To: T10 Technical Committee

From: Rob Elliott, HP (elliott@hp.com)

Subject: 03-354r0 SPC-3 Specify initiator ports in EXTENDED COPY target descriptors

Figure 1 — Example of a complex copy manager environment

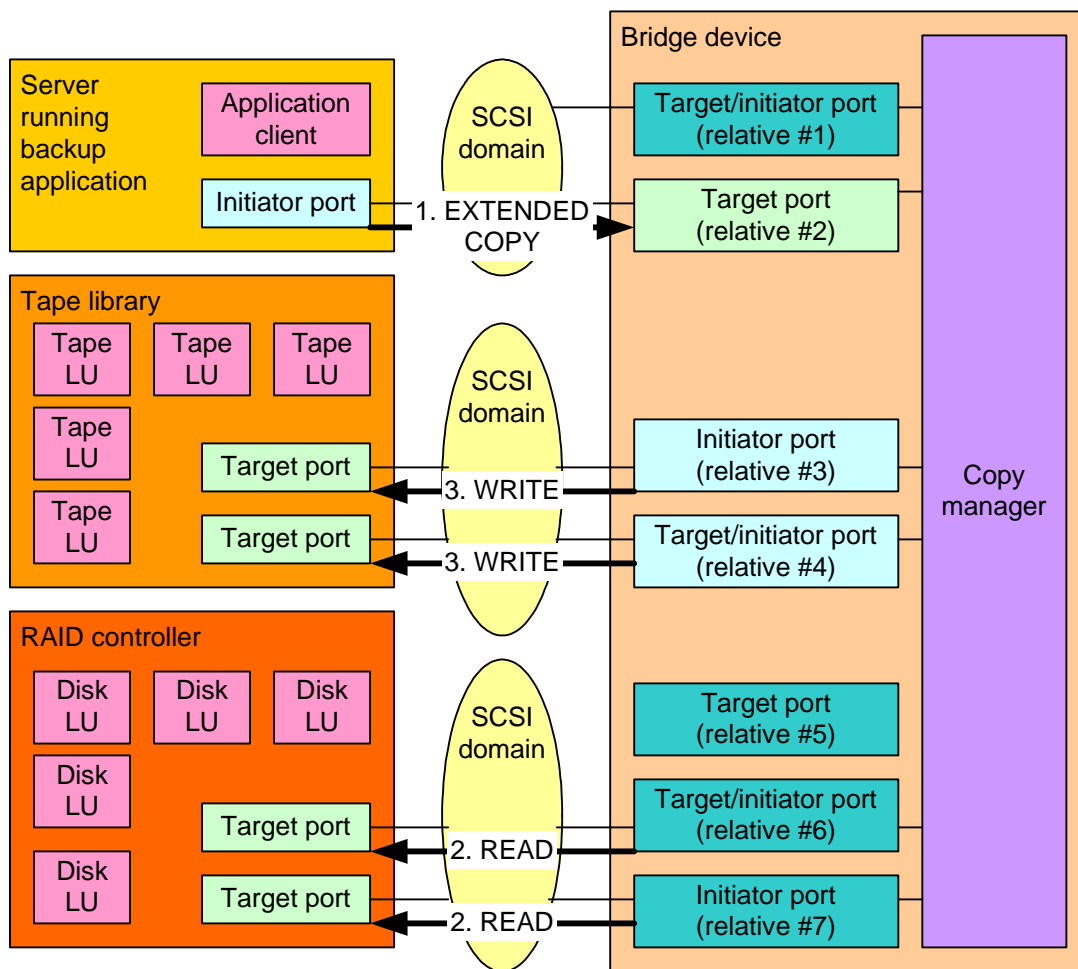
A copy manager can be in a SCSI device with multiple initiator ports, each potentially in different SCSI domains (thus with access to a different set of target ports).

1. Send EXTENDED COPY to copy manager through target port #1 (or #2)
2. Copy manager reads from disks using initiator ports #6 and/or #7
3. Copy manager writes to tapes using initiator ports #3 and/or #4
4. EXTENDED COPY completes through target port #1 (or #2)

EXTENDED COPY is silent today on which initiator port to use. This proposal adds a initiator port field to the EXTENDED COPY target descriptor so selected initiator ports can be chosen. The default value of zero means the choice is vendor-specific, which is compatible with current implementations.
